Access Compliance Report

Public Rights-of-Way

Intersection ID: 44306	Main Street: MALLORY_TAYLOR_LN	Cross Street: LINDA_VISTA_LN	Location: SE
ADA ID: 8EA455C33CB7	Ramp Type: Perpendicular Diagonal	Initial Pass/Fail: Fail	Overall Compliance: No
		Severity Score: 8.75	
Codes/Mitigation Info/Possible Solution		Field Measurements/Component Compliance

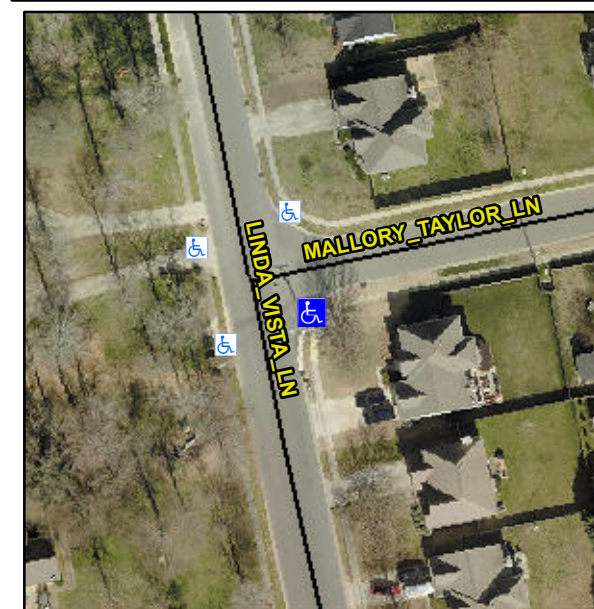
Not Found, R304.5.1

Compliance	Description	Data	Compliance	Description	Data
N/A	Ramp Length (in)	49.0	Yes	Ramp Slope (%)	5.4
No	Ramp Width (in)	40.0	Yes	Ramp XSlope (%)	1.3
N/A	Flare Type LT	N/A	N/A	Flare Type RT	N/A
N/A	Flare Slope LT (%)	N/A	N/A	Flare Slope RT (%)	N/A
N/A	Flare Traversable LT?	N/A	N/A	Flare Traversable RT?	N/A
N/A	Landing Length (in)	N/A	N/A	DWS Provided?	N/A
N/A	Landing Width (in)	N/A	N/A	DWS Contrast?	N/A
N/A	Landing Slope (%)	N/A	N/A	DWS Length (in)	N/A
N/A	Landing X Slope (%)	N/A	N/A	DWS Full Width?	N/A
N/A	Landing Curb? (Y/N)	N/A	N/A	DWS Offset (in)	N/A
N/A	Shared Landing?	N/A			
N/A	Gutter Ponding?	N/A	N/A	Gutter Slope (%)	N/A
N/A	Gutter Lip Ht (in)	N/A	N/A	Gutter X Slope (%)	N/A
N/A	Painted X Walk1?	No	N/A	Painted X Walk2?	No
	X Walk 1 Direction	To N		X Walk 2 Direction	To W
N/A	X Walk 1 Width (in)	N/A	N/A	X Walk 2 Width (in)	N/A
	X Walk 1 Slope (%)	0.0		X Walk 2 Slope (%)	1.7
	X Walk 1 X Slope (%)	4.0		X Walk 2 X Slope (%)	3.3

Remove & Replace Curb Ramp With Two New Directional Ramps or Equivalent.
